<b>AMENDMENT OF SOLICITATION/MODIFICATION OF CONTRACT</b>		1. CONTRACT ID CODE	PAGE OF PAGES
			1   11

2. AMENDMENT/MODIFICATION NO. <b>A00029</b>	3. EFFECTIVE DATE <b>See BLK 16</b>	4. REQUISITION/PURCHASE REQ. NO. <b>HSCG23-06-D-ARB001</b>	5. PROJECT NO. (If applicable) <b>RB-M</b>
--	--	---	---

This No Cost Modification incorporates Contract Change language to correct, clarify and amend portions of Section I – Contract Clauses, Section J – Statement of Work, and Section J - Specification.

**Figure 051-1 Operational Envelope**

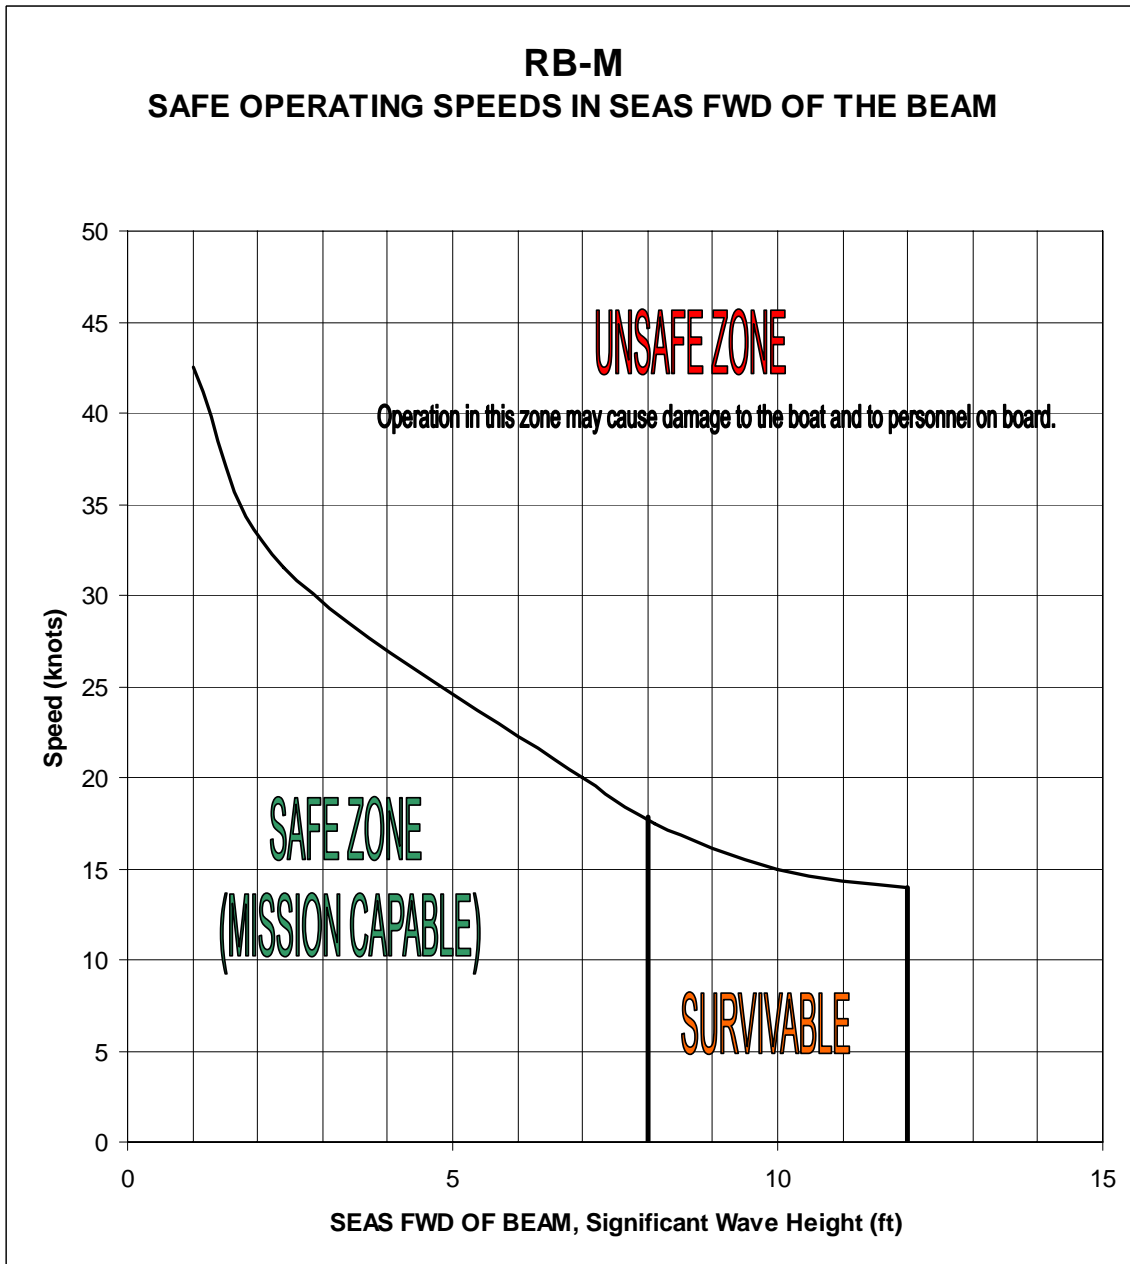
- a. Revised paragraph 051-2.1, Reference USCG letter 085-R0070, dated 9 March 2007. Add language and Operational Envelope figure.
- b. Added paragraph 075-1.8, Reference USCG letter 551-R0674, dated 20 August 2008. Add language authorizing specific use of black nylon cable ties.

051-2.1 [A00029] The RB-M shall minimize the degradation of safe operating speed in increasing sea states. **At a minimum, it shall be capable of operating at the speed and sea conditions shown in Figure 051-1.**
